PLANNING COMMISSION MEETING

August 6, 2026 - 6:00 PM
City Hall Council Chambers

To: Planning Commission
From: Kris Jenson, Planning Manager
Date: July 29, 2026
Subject: Packet Material for the August 6, 2026 Planning Commission Meeting
Agenda Item: Kenwood Hills 4th Addition preliminary and final plat, development stage plan, and easement vacation
Action Deadline: August 18, 2026

To: Planning Commission
From: Heather Botten, Senior Planner
Date: July 22, 2026
Subject: Packet Material for the August 3, 2026 Planning Commission Meeting
Agenda Item: Highview Preliminary Plat
Action Deadline: August 31, 2026

PRELIMINARY GRADING PLAN

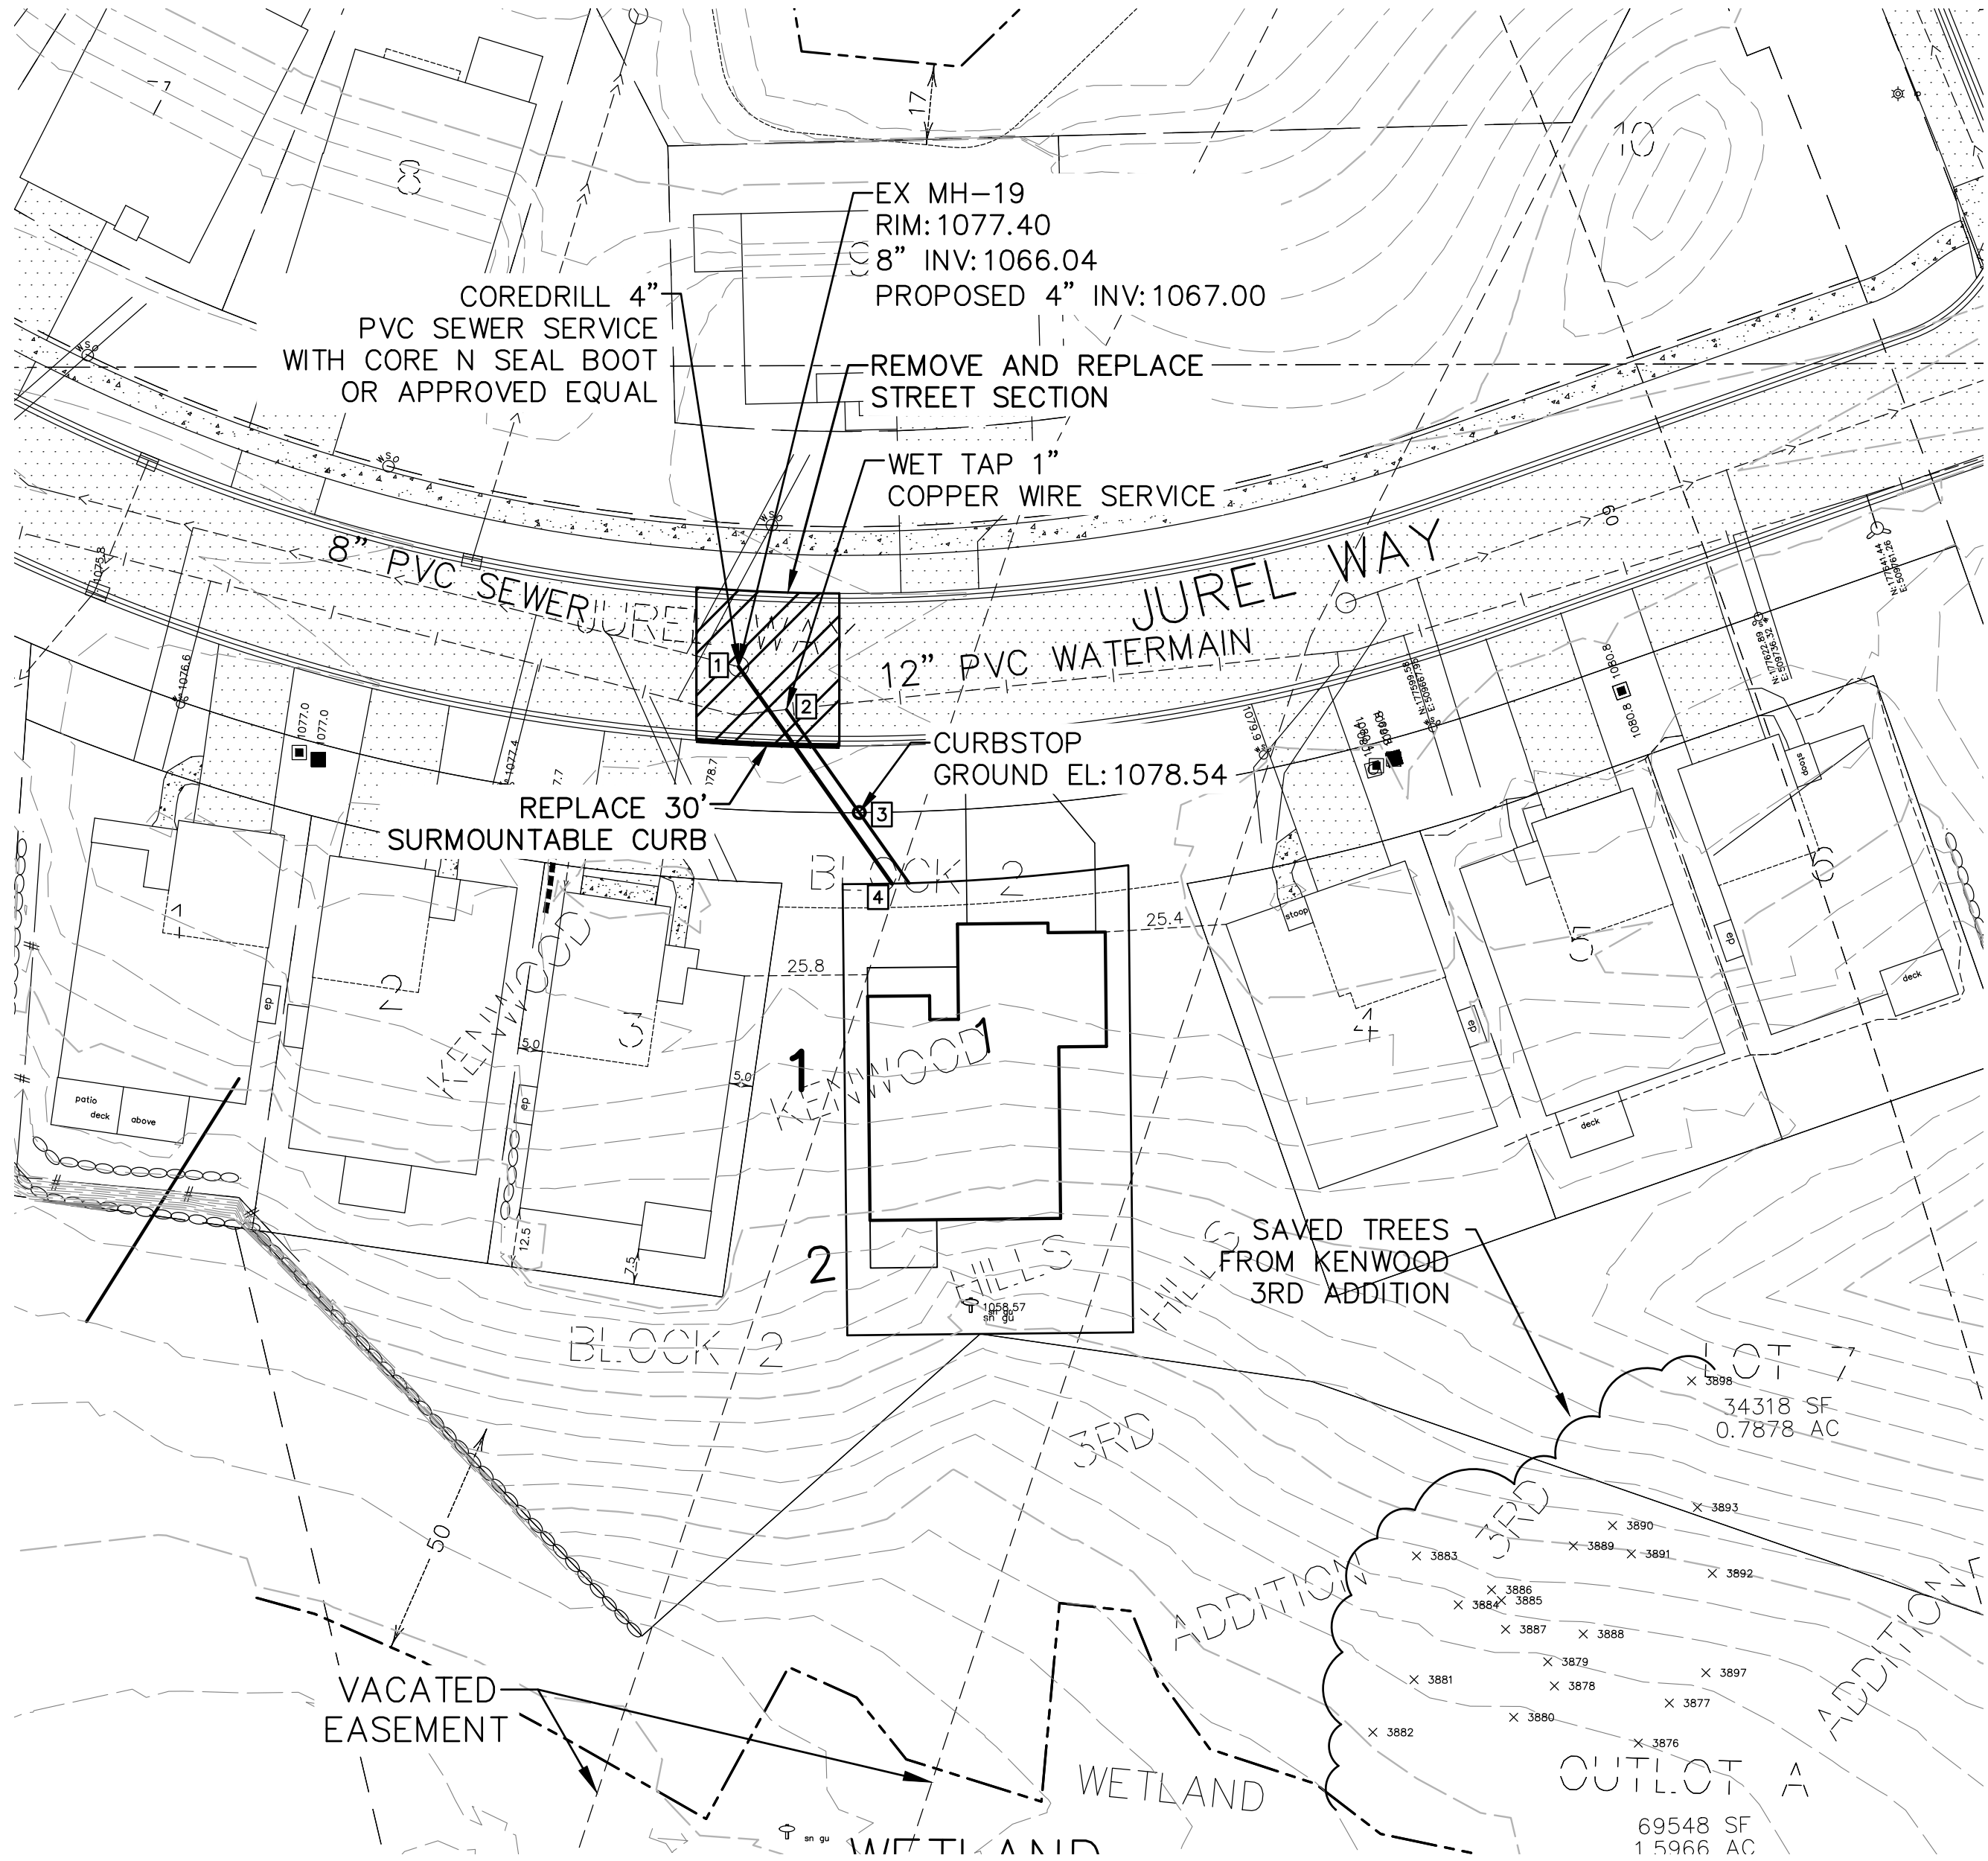
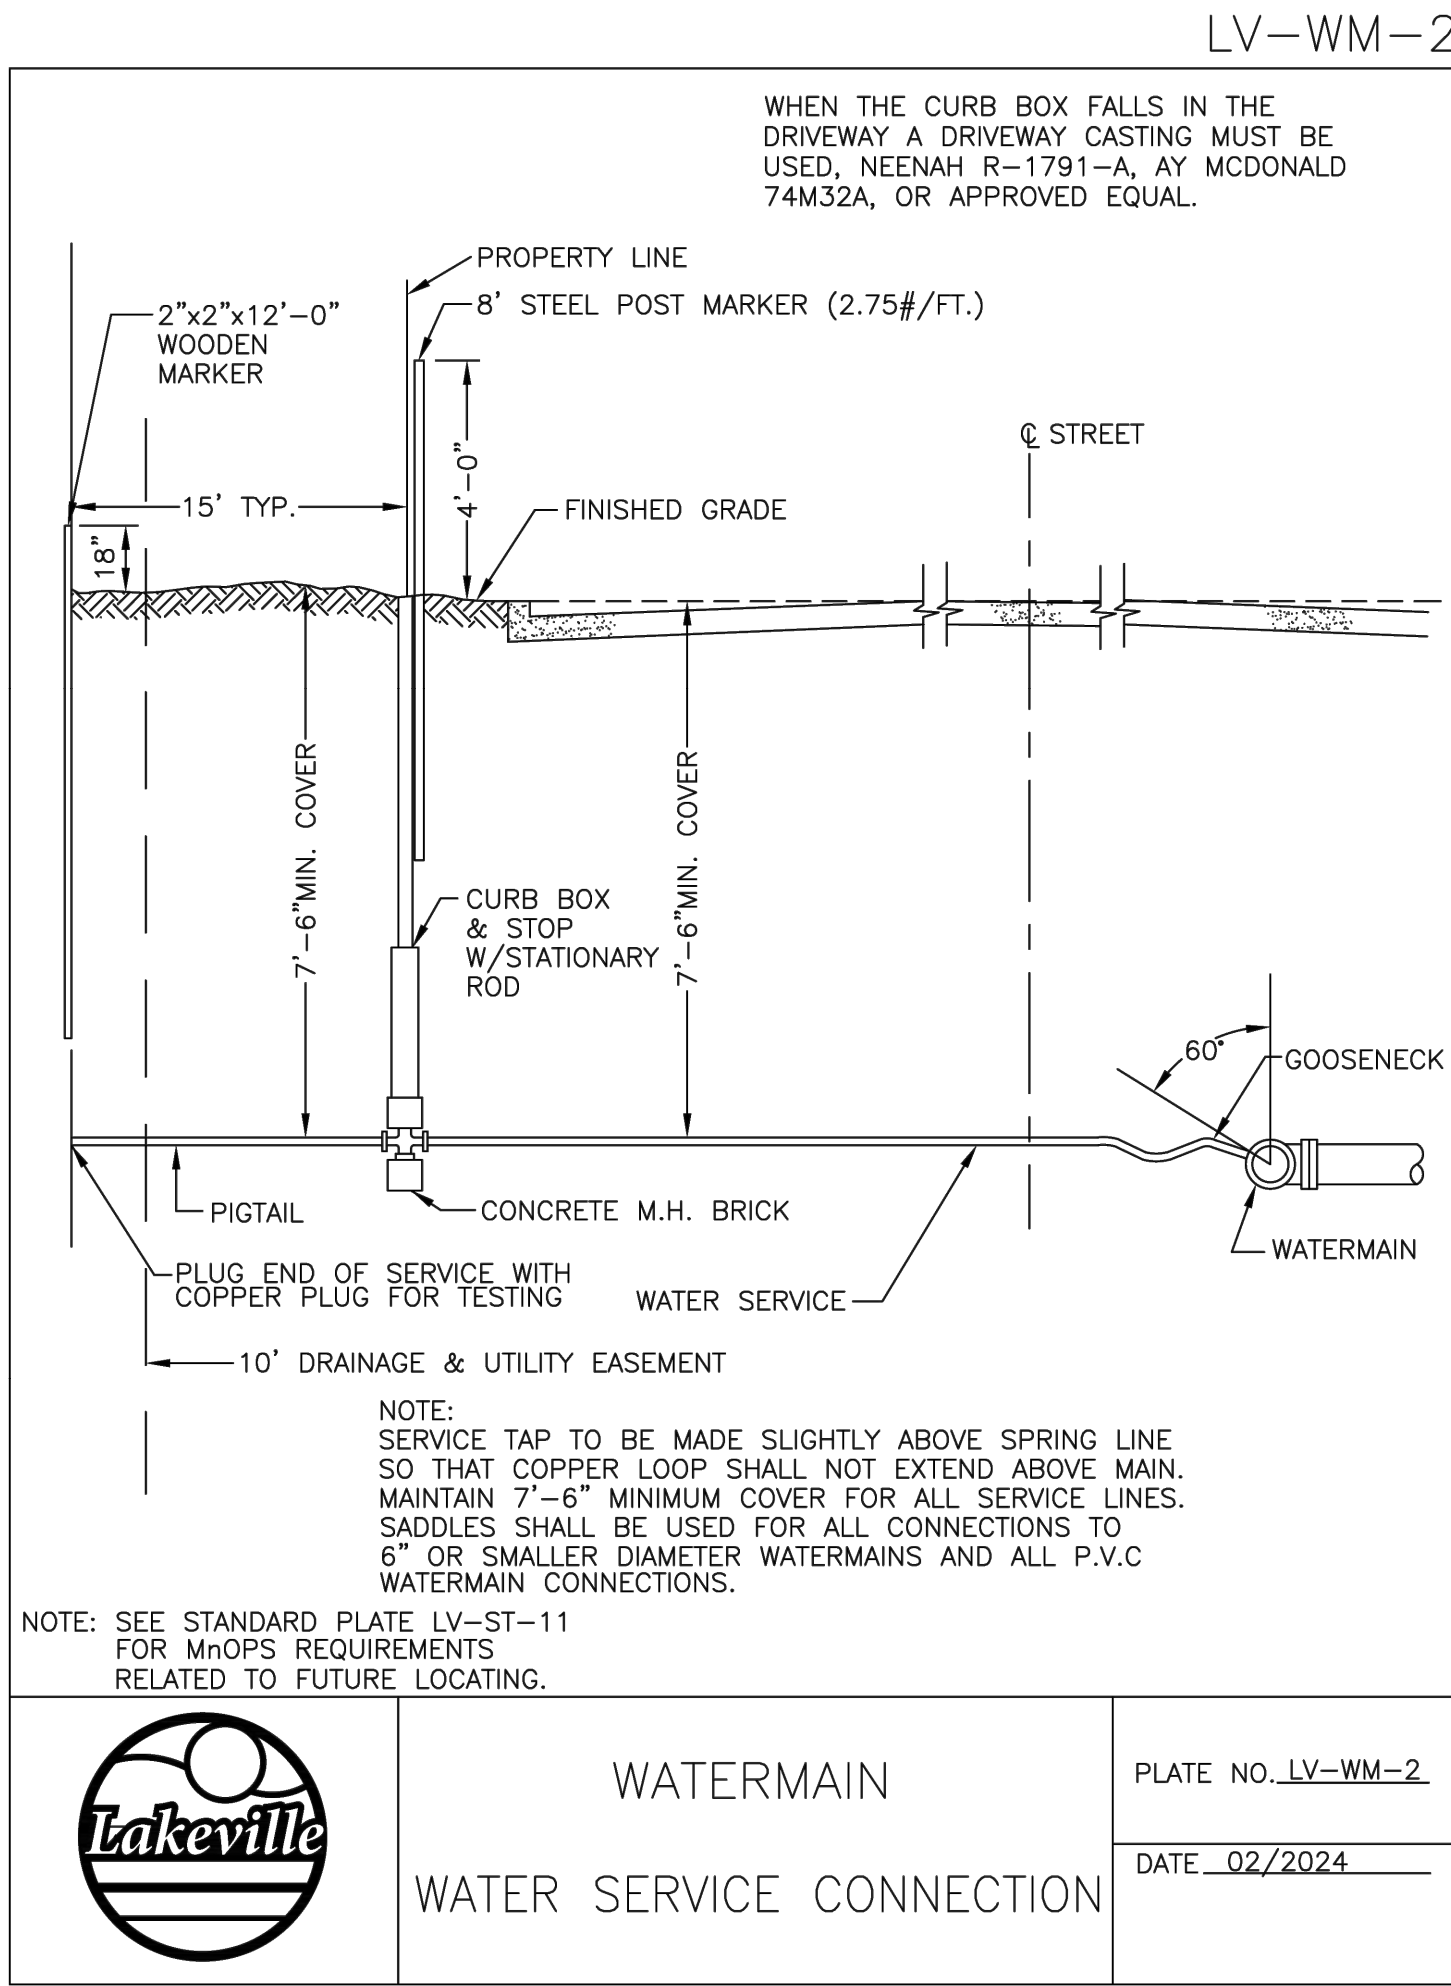
Prior to City Council consideration of the preliminary and final plat, a notation must be added to the grading plat that there are no significant trees within the limits of construction.

The final grading plan shall identify all fill lots in which the building footings will be placed on fill material. The grading specifications shall also indicate that all embankments meet FHA/HUD 79G specifications. The Developer must certify to the City that all lots with footings placed on fill material are appropriately constructed. Building permits will not be issued until a soils report and an as-built certified grading plan have been submitted and approved by City staff.
